LIGO CALIFORNIA INSTITUTE OF TECHNOLOGY MASSACHUSETTS INSTITUTE OF TECHNOLOGY	SYSTEM	aLIGO AOS
	SUB-SYSTEM	AOS
NEXT ASSY	D1000549

PART NAME		TMS INTERMEDIATE OSUM SUPPORT PLATE, REAR	
DESIGNER	I. ROMERO	DATE	04 FEB 2010
DRAFTER	I. ROMERO	DATE	6/29/10
CHECKER	K. MAILAND	DATE	6/29/10
APPROVAL	K. MAILAND	DATE	6/29/10
SIZE	DWG. NO.	REV.	
B	D1000411	v2	
SCALE	NONE	PROJECTION	
SHEET 1 OF 2

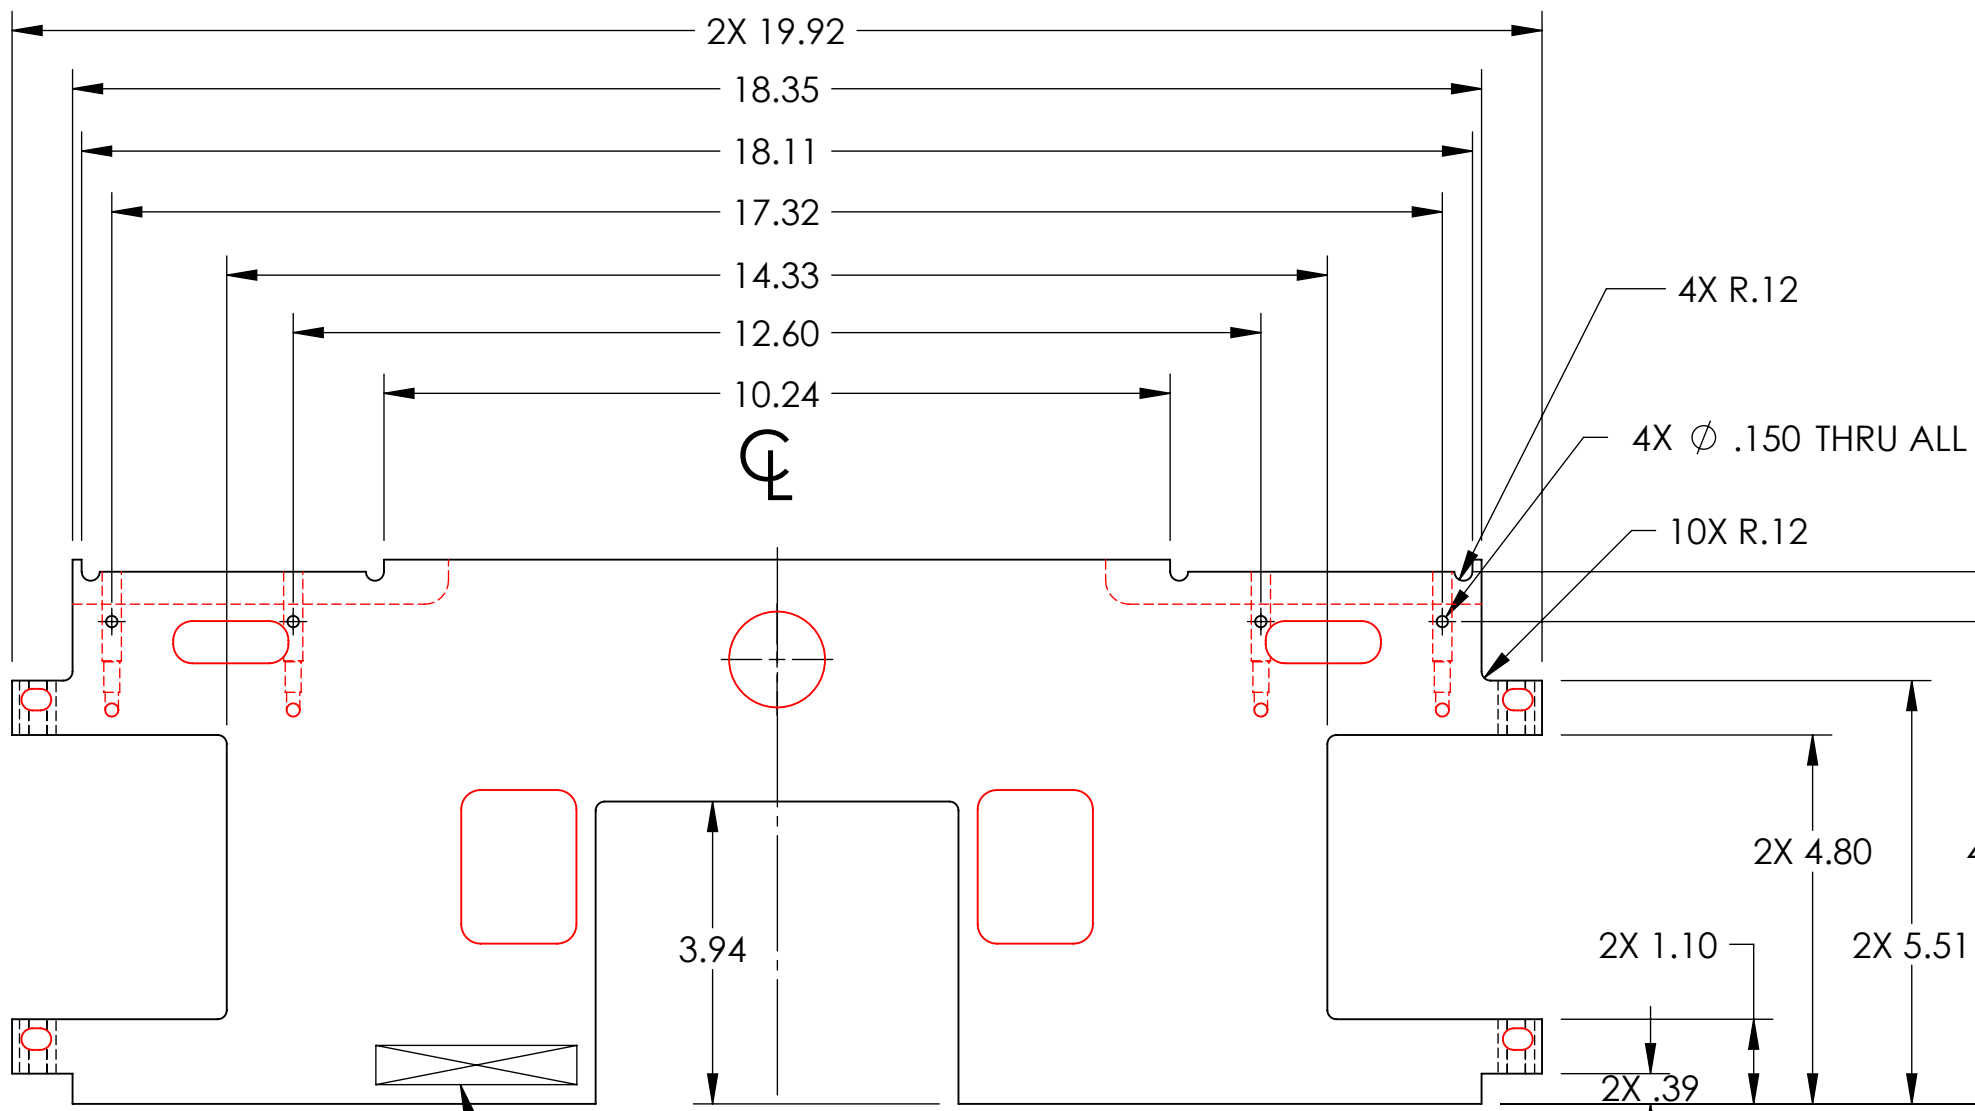
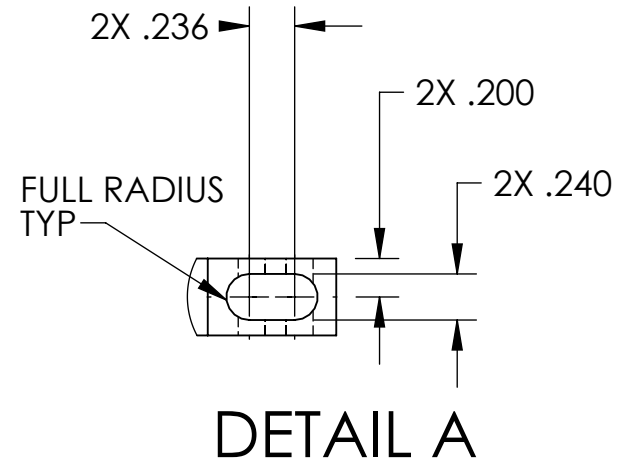
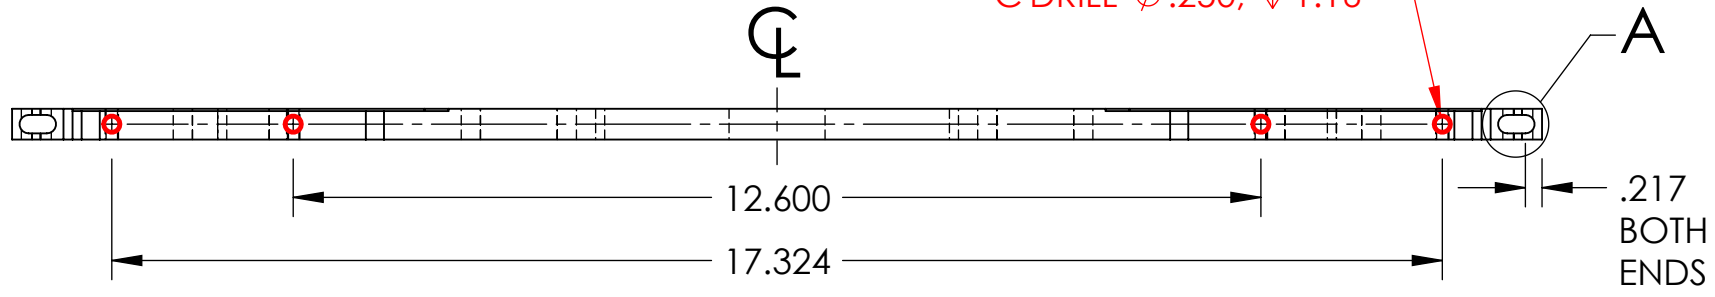
4X  $\phi$  .173  $\nabla$  1.80  
 TAP FOR #8-32 (H3) HELICOIL INSERT = 2.0 \* DIA.  
 P/N 1185-2EN-328 (INSTALLED BY LIGO)  
 C'DRILL  $\phi$  .250,  $\nabla$  1.16

10. THIS DRAWING IS FOR EXISTING PART REWORK. REWORK DETAILS ARE IN RED.  
 11. MARK OUT OLD REVISION LABEL AND REPLACE WITH "v2".
